# 23 Case #SUB2007-00201

## HIDDEN PINES SUBDIVISION, UNIT FIVE

## DETAIL SITE PLAN

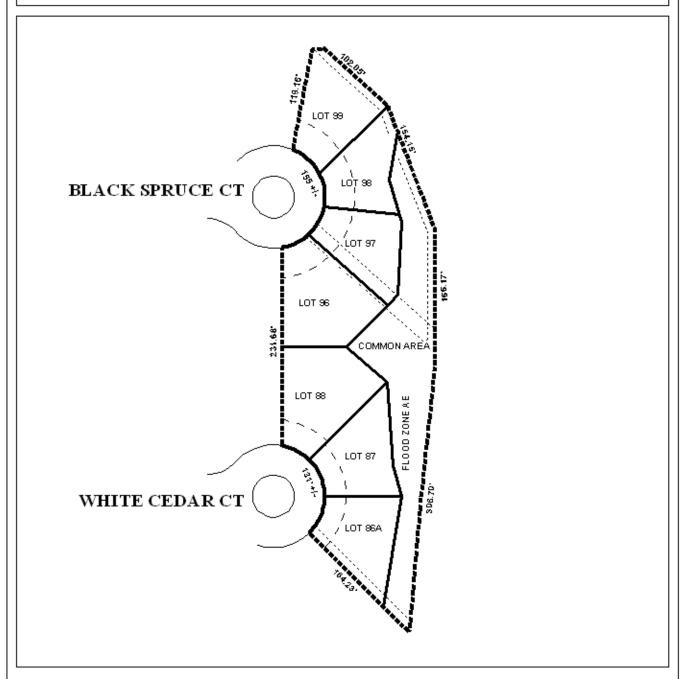
The proposed lots show at least a 25-foot minimum building setback line, with some lots depicting a setback line of 35-feet. While it appears that proposed Lot 98, fronting onto Black Spruce Court, will present a challenge to a homebuilder, it along with the other proposed lots meet the minimum area requirements of the Subdivision Regulations.

Due to the limited frontage of each lot onto the cul-de-sacs, each lot should be limited to one curb-cut, with the size, design and location to be approved by the Mobile County Engineering Department.

As previously mentioned, the site may be located within the floodplain for a branch of Muddy Creek. Other data indicates that the site may have at one time included wetlands as well, however, aerial photographs indicate that the site has been cleared since at least 2002. The potential presence of wetlands and floodplains indicate that the area may be environmentally sensitive; therefore, the approval of all applicable federal, state and local agencies would be required prior to the issuance of any permits or land disturbance activities.

While the site is in Mobile County, it will have to comply with the City of Mobile storm water and flood control ordinances. A note should be placed on the final plat stating that the development will be designed to comply with the storm water detention and drainage facility requirements of the City of Mobile storm water and flood control ordinances, and requiring submission of certification from a licensed engineer certifying that the design complies with the storm water detention and drainage facility requirements of the City of Mobile storm water and flood control ordinances prior to the issuance of any permits. Certification is to be submitted to the Planning Section of Urban Development and County Engineering.

- 1) the labeling of all common areas, including storm water detention areas, and the placement of a note on the final plat stating that maintenance of common areas shall be the responsibility of the property owners, as depicted;

- 2) the labeling of each lot with its size in square feet, as depicted, or provision of a table on the plat depicting the same information;
- 3) placement of a note on the plat stating that each lot is limited to one curb-cut each, with the size, design and location to be approved by the Mobile County Engineering Department;

- 4) placement of a note on the plat stating that the development will be designed to comply with the storm water detention and drainage facility requirements of the City of Mobile storm water and flood control ordinances, and requiring submission of certification from a licensed engineer certifying that the design complies with the storm water detention and drainage facility requirements of the City of Mobile storm water and flood control ordinances prior to the issuance of any permits. Certification is to be submitted to the Planning Section of Urban Development and County Engineering.;

- 5) approval of federal, state and local agencies, as necessary due to wetlands and floodplains, prior to the issuance of any permits; and
- 6) placement of a note on the final plat stating that any lots which are developed commercially and adjoin residentially developed property must provide a buffer, in compliance with Section V.A.7. of the Subdivision Regulations.
